BAKLEY FIELD WAY INDICATE NORTH - NAME ADJOINING ROADWAY AS BASE LINE

DATE SYSTEM APPROVED 4/28/98 INSPECTOR M. Ripkin

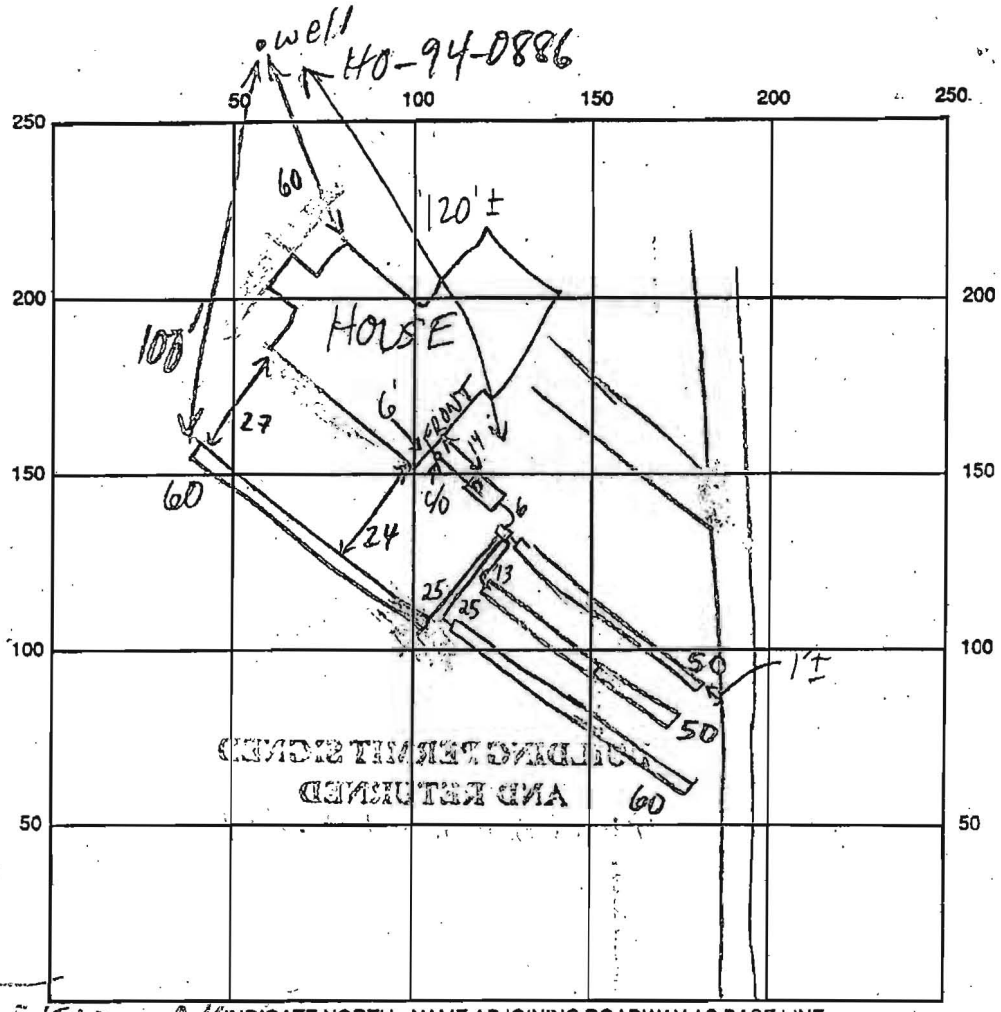
REMARKS: 4/27/98 Preconstruction site insp - Minimum 50' trench length in 1st maybe 2nd trench not possible - install as much as will fit even if <50' in length of 4/28/98 OK TO COVER ALL (MR)
5·26·98 WPI ok to cover, line sleeved P.A. 4.0' below grade, casing 2.0' above grade, has 2 piece cap KM
